This is the first in an on-going series of newsletters designed to update our Warranty and Repair network on parts changes that have taken place in our reels, and the reasons for those changes. Newsletters will be mailed to our Warranty and Repair shops, and will also be available for access at any time on our website. The first few newsletters will attempt to chronicle all the various changes that have been made to Penn reels over the past several years. Once we have updated the most recent history of changes, we will issue an ongoing newsletter several times a year whenever changes are made. We hope these newsletters provide you the information you need to better service your customer repairs. Please contact us if there is any further information you need, or if anything in the newsletter needs to be clarified. We appreciate your support. Special thanks to Jimmy Reynolds of J.R.'s Reel Repair who assisted in the writing of this newsletter.

“SENATOR SERIES CHANGES”

3. 114 Click Button

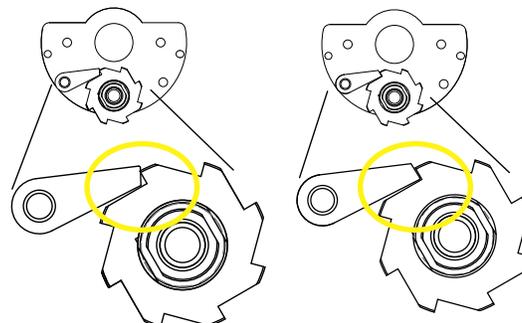
We have replaced the riveted click button to one that is removable (utilizing a retaining ring), making the replacement of the click tongue much easier. The part number has changed from (036 114) to (036 114H), the retaining ring number is (069B600). This change took effect in October, 1999.
